Re: FortisBC Inc. (FBC)

**Application for a Certificate of Public Convenience and Necessity for Approval
of the Fruitvale Substation Project (Application)**

**Response to the Commercial Energy Consumers Association of British
Columbia (CEC) Information Request (IR) No. 1**

Figure 4-1: One-Transformer Substation Compared to Existing FRU Substation Size⁵

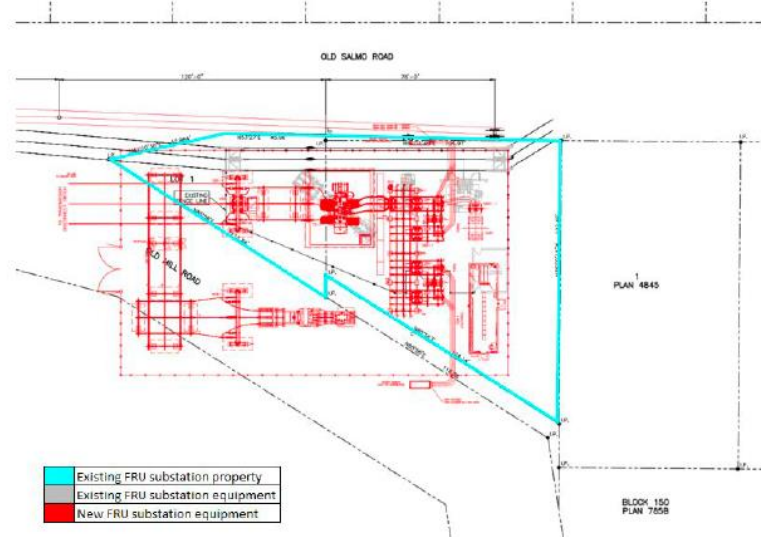
6.1 It appears that two of FBC's alternatives were rejected due primarily to FBC's station design requirements and constructability challenges. Please elaborate on the FBC design standards and associated constraints and explain if these are:

- FBC specific constraints or industry standard or regulated by a specific authority;
- whether or not FBC has or may exceed the constraints where circumstances warrant; and
- if so, how this has been or could be accomplished.

Please refer to the response to BCUC IR1 7.4.
